Road Safety Audit Stage 1

Junction Improvements

Brighton Hill Roundabout

Document reference: 01/308

Annotated Plan

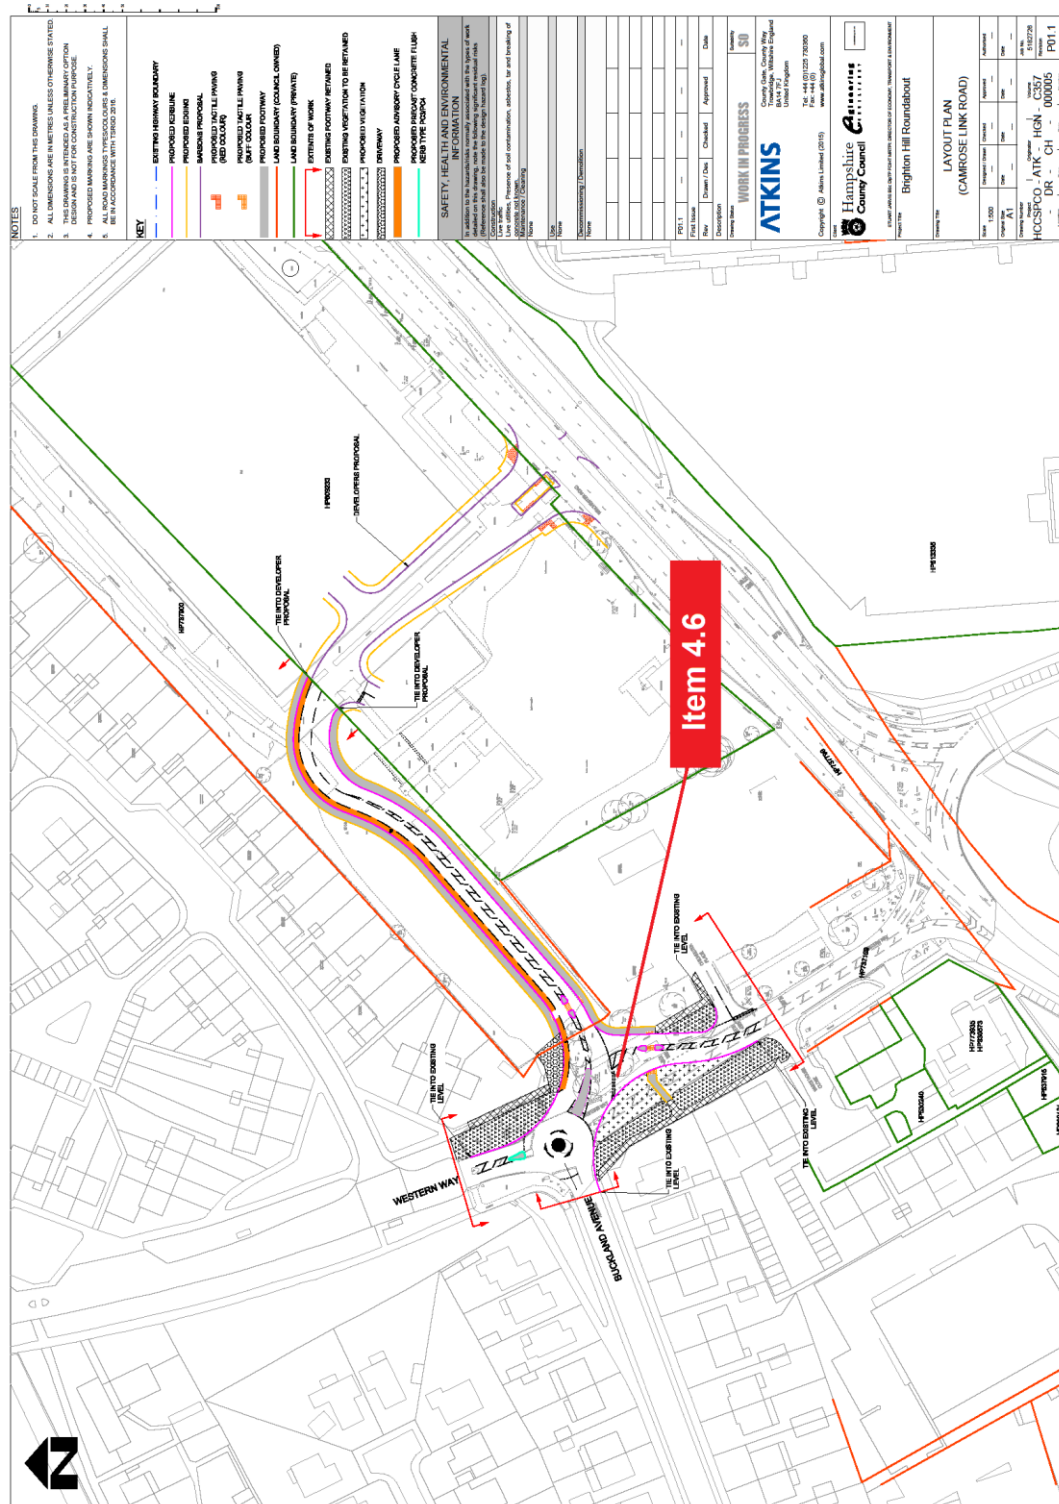
- 1.7 The location of the problems identified are shown on the annotated plan.

4.1 Problem

Location: Throughout the scheme.

Summary: A lack of cycle infrastructure will increase the risk of collisions between cyclists and pedestrians/vehicles.

The proposed at-grade crossings will be toucans, but there is no cycle infrastructure to connect these crossings with any existing off-road cycle routes or provide a link to the existing road network. As a result, cyclists may carry out undesirable manoeuvres which could lead to collisions with vehicles or pedestrians.

4.2 Problem

Location: The proposed segregated cycleway/footway on the A30 Winchester Road (east) and Brighton Way.

Summary: An incomplete cycle network will result in cyclists carrying out undesirable manoeuvres that may lead to collisions with vehicles or pedestrians.

There are proposed sections of segregated footway/cycleway on both sides of Winchester Road (east) and on the east side of Brighton Way, but these do not connect with any existing off- road cycle routes and there are no transitions to and from the carriageway. As a result, cyclists may continue along the footway or rejoin the carriageway at undesirable locations. This could lead to collisions with pedestrian or vehicles.

4.3 Problem

Location: The existing safety fencing around the outside of Brighton Hill roundabout.

Summary: Sections of safety fencing will have to be removed to facilitate the at-grade crossings.

There is existing safety fencing around the outside of the roundabout to prevent vehicles from entering the steep drops to the subway ramps. If the safety fencing is removed to facilitate the at-grade crossings, there is a risk of errant vehicles entering these areas which could increase the severity of a collision.

4.4 Problem

Location: The proposed ramp to the crossing on A30 Winchester Road (west)

Summary: The proposed ramp will be too steep for mobility impaired pedestrians to negotiate.

From a visual assessment, it looks as though the proposed ramp to the crossing on A30 Winchester Road (west) will be much steeper than the maximum recommended gradient for mobility impaired pedestrians. Wheelchair users may be unable to negotiate the ramp and there is a risk of tipping accidents.

4.5 Problem

Location: The proposed ramp to the south side of the crossing on old Winchester Road.

Summary: The proposed ramp may be too steep for mobility impaired pedestrians to negotiate.

From a visual assessment, it looks as though the proposed ramp to the crossing on old Winchester Road will be steeper than the maximum recommended gradient for mobility impaired pedestrians. Wheelchair users may be unable to negotiate the ramp and there is a risk of tipping accidents.

4.6 Problem

Location: The section of Western Way south of the new Camrose Link Road.

Summary: Difficult or inappropriate turning manoeuvres onto the new link road.

Traffic heading towards the A30 Winchester Road from the southern end of Western Way are prevented from turning right onto the new Camrose Link Road by an extended splitter island, and instead will have to turn left and then U-turn at the mini roundabout. It is unclear if vehicles, particularly Pizza Express delivery vehicles, are able to make this manoeuvre without being unduly restricted. There is also a risk of drivers attempting to turn right directly onto the link road to avoid the roundabout which may result in collisions with other vehicles.

Recommendation: Provide a coherent network of off-carriageway cycle links that connect the proposed toucan crossings to the strategic cycle network.

Recommendation: Provide a coherent cycle network.

Recommendation: Provide appropriate measure to protect vehicles from the steep drops.

Recommendation: The absolute maximum gradient of the ramp should be 1 in 12, but preferably no greater than 1 in 20. If this cannot be achieved, an alternative arrangement should be considered.

Recommendation: The absolute maximum gradient of the ramp should be 1 in 12, but preferably no greater than 1 in 20. If this cannot be achieved, an alternative arrangement should be considered.

Recommendation: Review the access arrangement for the southern end of Western Way onto the new Camrose Link Road.
